**EL PASO WATER UTILITIES
PUBLIC SERVICE BOARD**

ADDENDUM NO. 1

**MCGREGOR 16-INCH WATER LINE, FRANKLIN EAST 24-INCH WATERLINE
EXTENSION PHASE II AND NORTHEAST DYER INTERCEPTOR PHASE IV**

BID NO. 11-23

SHEET TITLE:
NORTH EAST DYER - PLAN AND PROFILE
FROM STA. 0+00 TO STA. 16+00

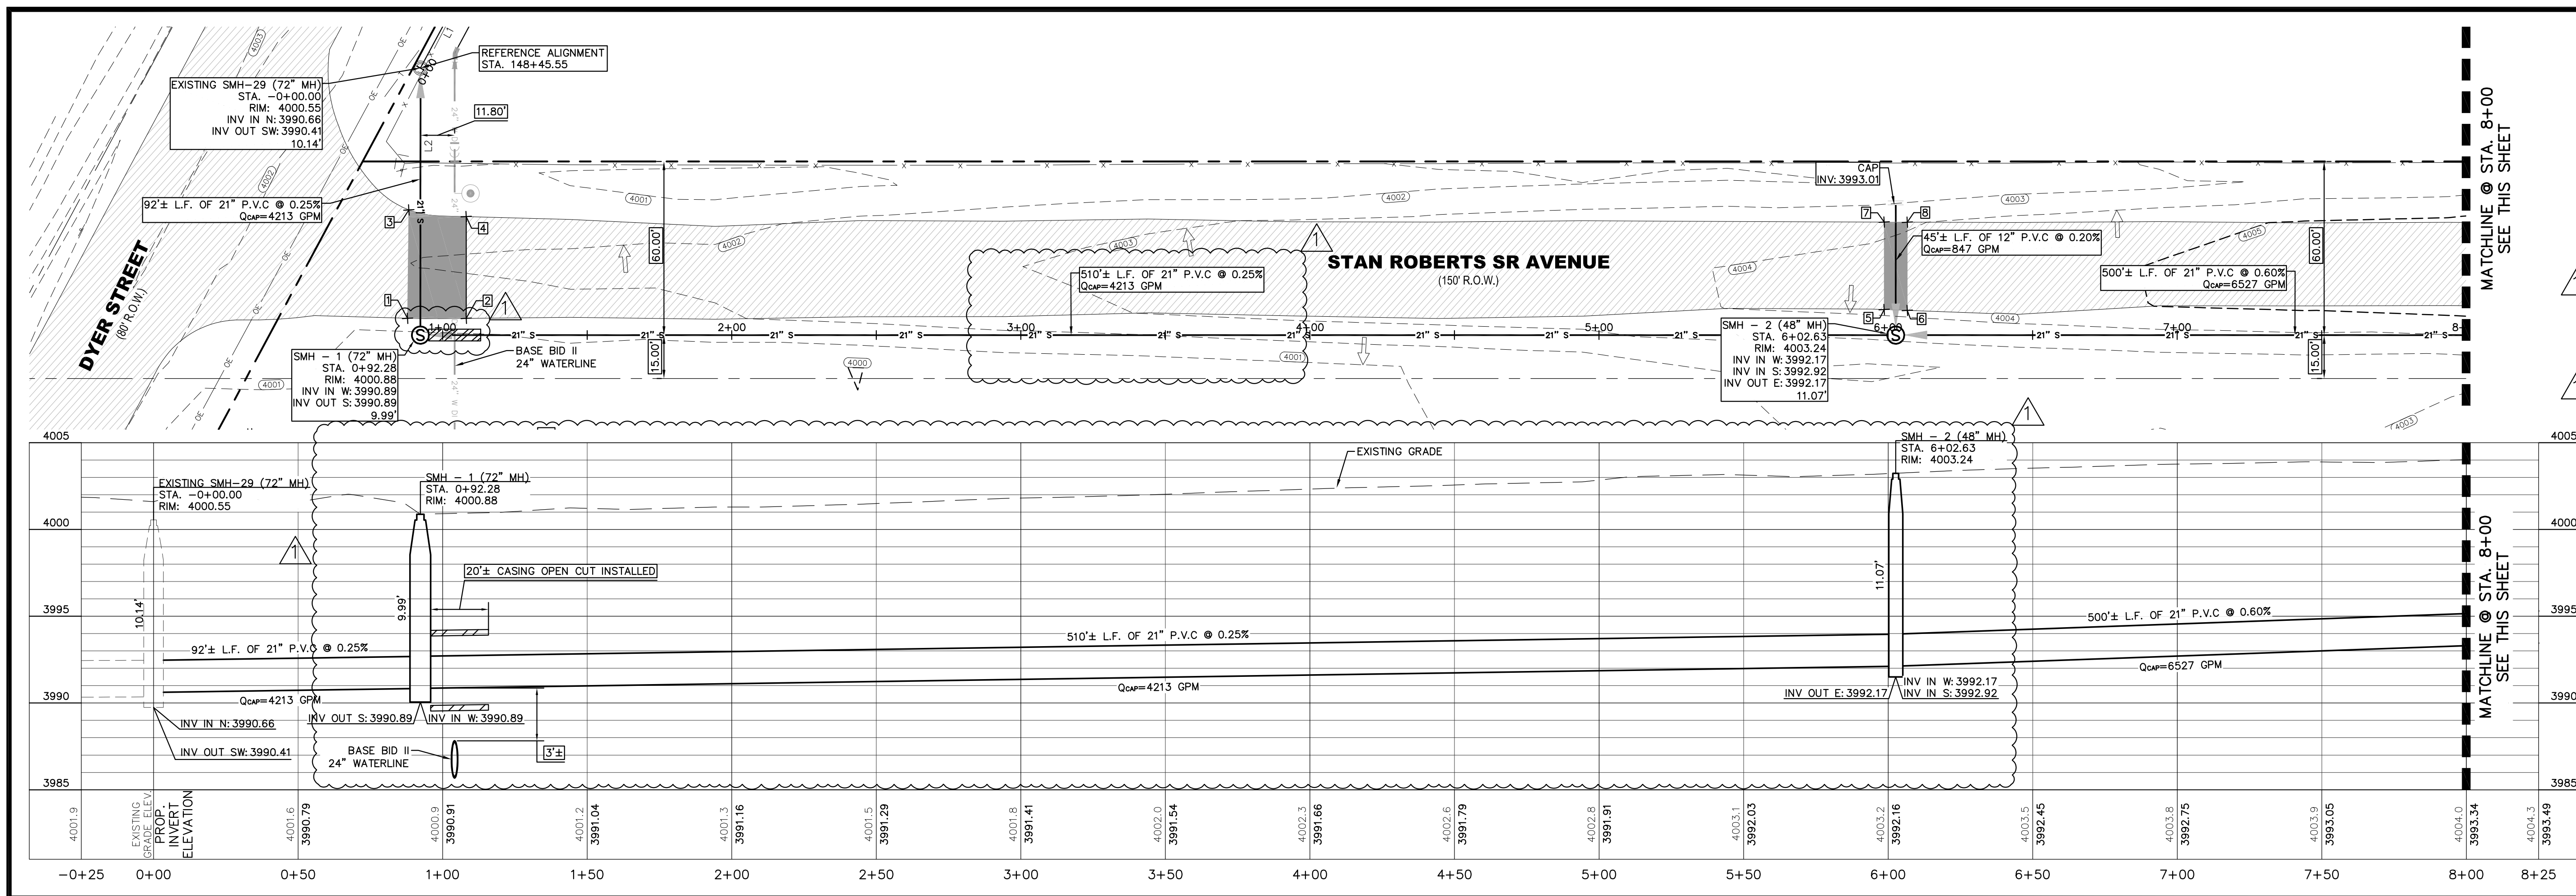
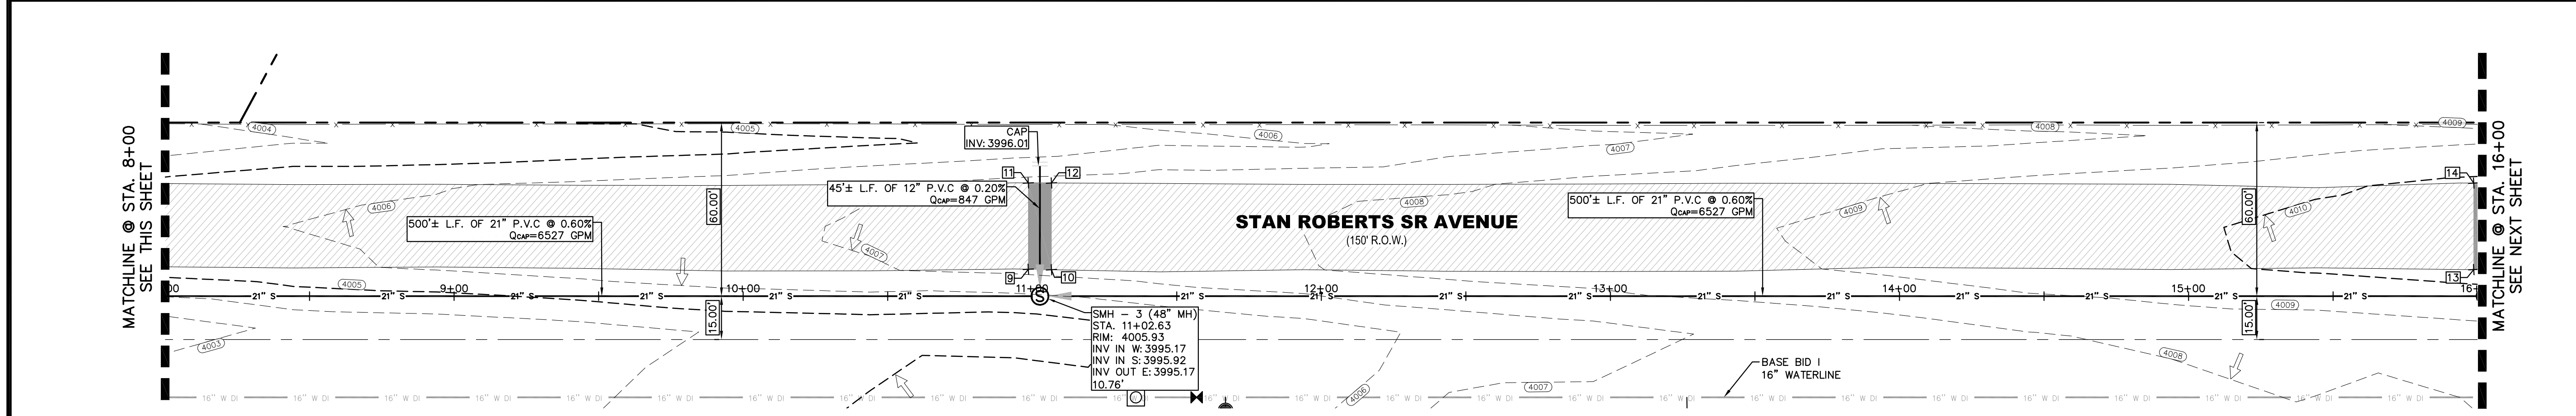
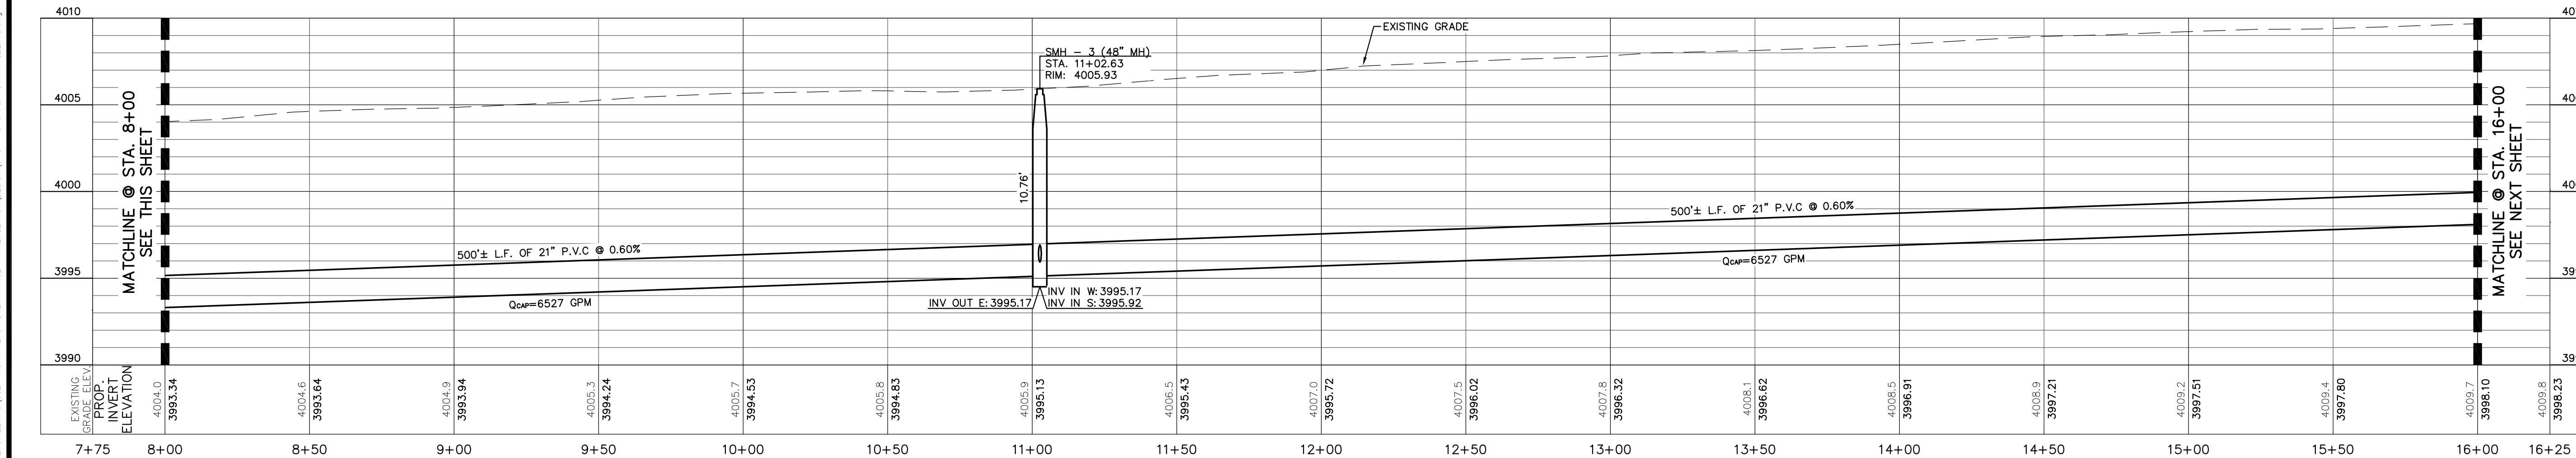
AD-1.03. SHEET C-4 – NORTHEAST DYER – PLAN AND PROFILE FROM STA. 0+00 to STA. 16+00

- A. REMOVE Sheet C-4 in its entirety and REPLACE with revised Sheet C-4R, attached to this Addendum.

Q-1.02. AWWA Does not contain a 21-inch diameter C900 pipe. Please clarify which size to install, 20-inch or 24-inch.

REV.	DATE	BY	DESCRIPTION
1	5/31/23	H.M.	REPLACEMENT OF PVC C900 WITH STEEL CASING

- A-1.02. The 21-inch C900 PVC pipe will be removed and replaced with 21-inch DR26, and a steel casing will be installed at the waterline crossing as shown in Sheet C-4R, attached to this Addendum.
